SUBJECT: CRYSTAL SPRINGS DRAINAGE IMPROVEMENTS

J. B. COXWELL CONTRACTING, INC.
CRYSTAL SPRINGS STORMWATER IMPROVEMENTS
CONTRACT 6533-55

Change Order No. Two (2) Date November 21, 2017

Description of Project Crystal Springs Stormwater Improvement Project

C-79

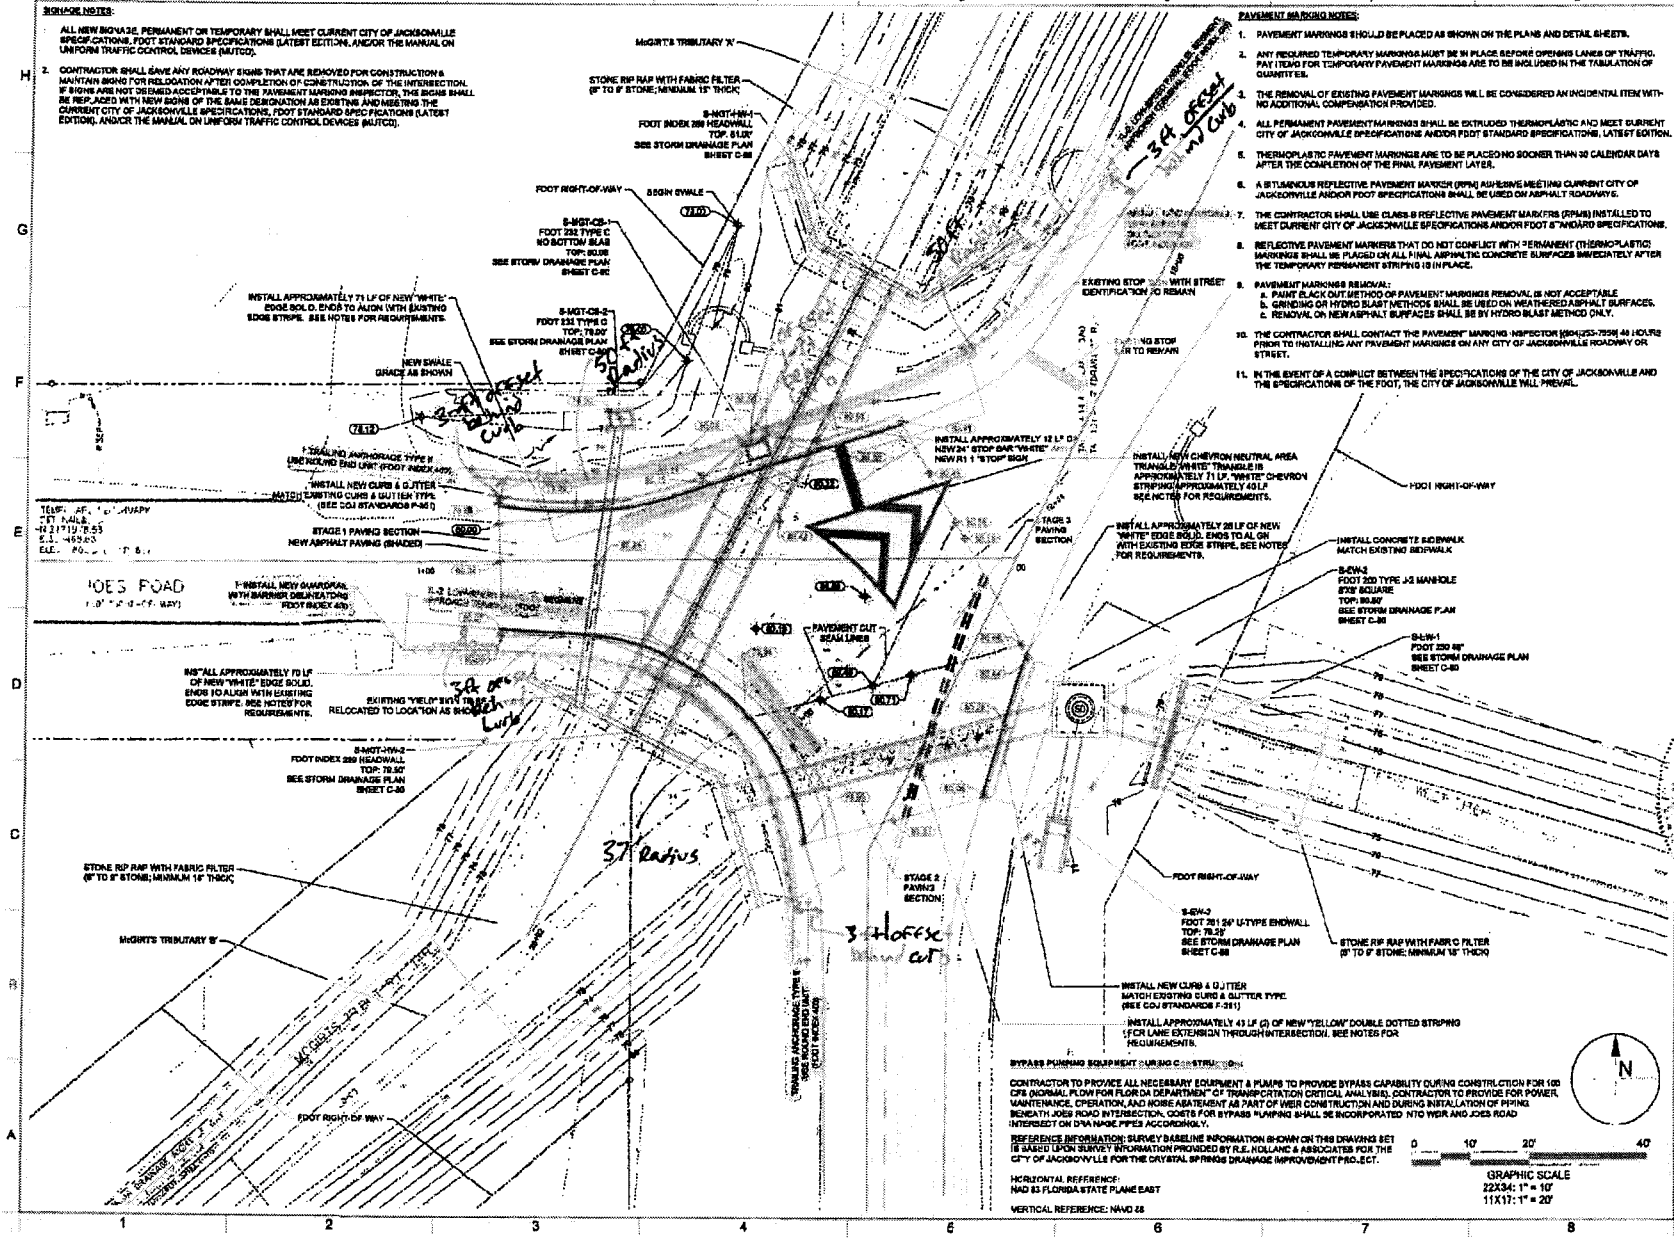
JBCCI submitted RFI #14 on 6/5/2017 requesting guidance for guardrail shown on plan sheet C-79 that was not included in the City of Jacksonville final bid proposal package. No pay items were included that were associated with the purchase and installation of this guardrail. The EOR responded to install the guardrail as shown on plan sheet C-79, and to follow FDOT Specification 536 and Standard Index 400. A sketch with additional details was also provided.

Response: Guardrail on both the North and South side of the intersection should be constructed as shown on sheet C-79. See attached sketch and revised plan sheet for cross-slope, offset, misc. asphalt details and end treatments. FDOT Specification 536 and Index 400 should be followed. Post in conflict with the box-culvert and 48" concrete pipe should be modified and installed per the encased guardrail post detail included in FDOT index 400.

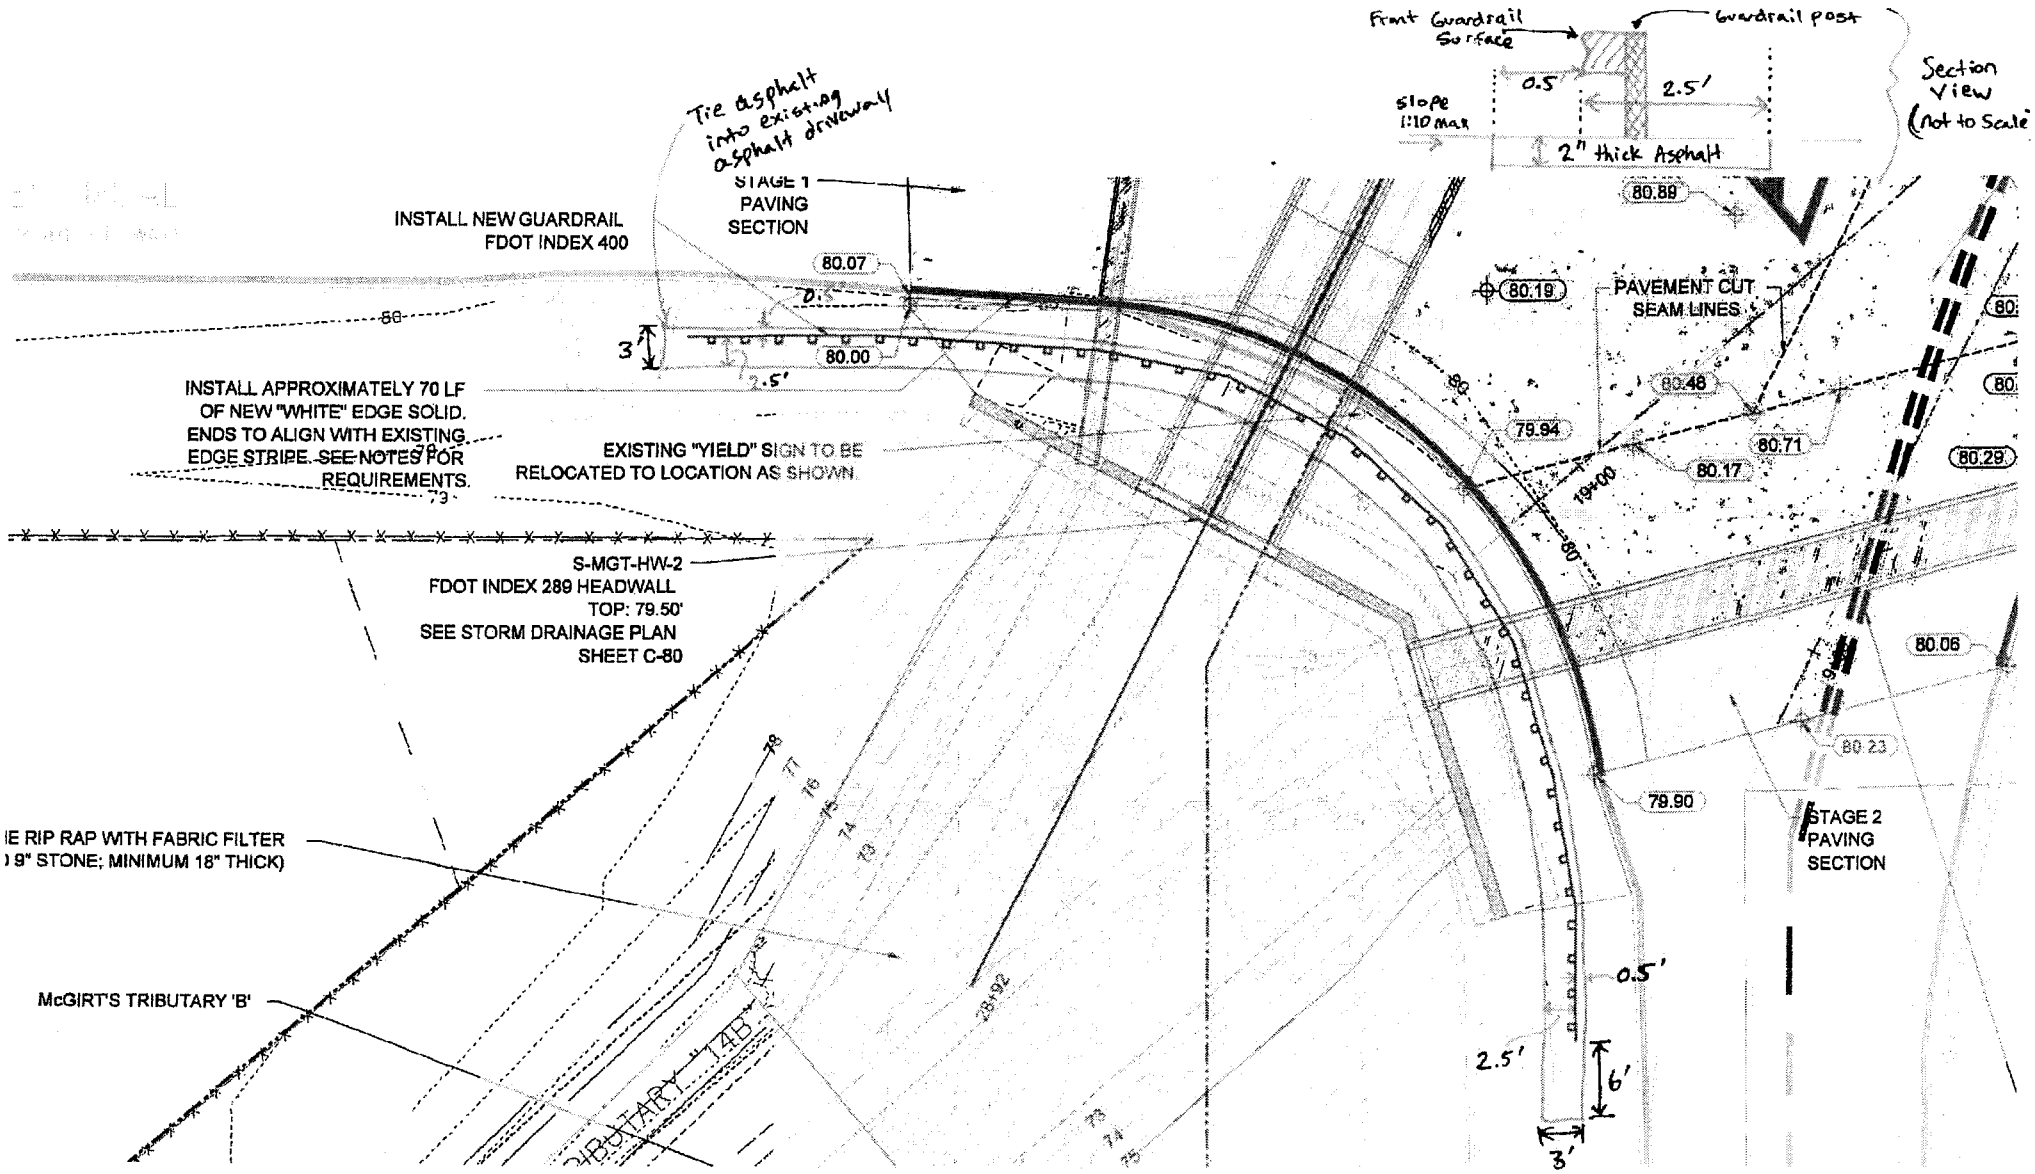
According to the project plans on sheet C-79, there is a guardrail shown between the southern headwall and roadway at the Joes and Blair Roads intersection. The guardrail specified on the plan sheet is approximately 100 linear feet of FDOT Index 400 guardrail. According to the City of Jacksonville's pay application in the final bid proposal package and the pay items listed in Addendum No.5, there is no pay item associated with or for the purchase and installation of this guardrail. Further, this guardrail does not appear to be addressed within the project specifications. JBCCI requests clarification on whether the COJ wants this section of guardrail to be installed as part of this project and if so, please provide specifications on this section of guardrail such that quotes can be obtained. Please advise as soon as possible such that this work can be added to the existing scope of work for the intersection.
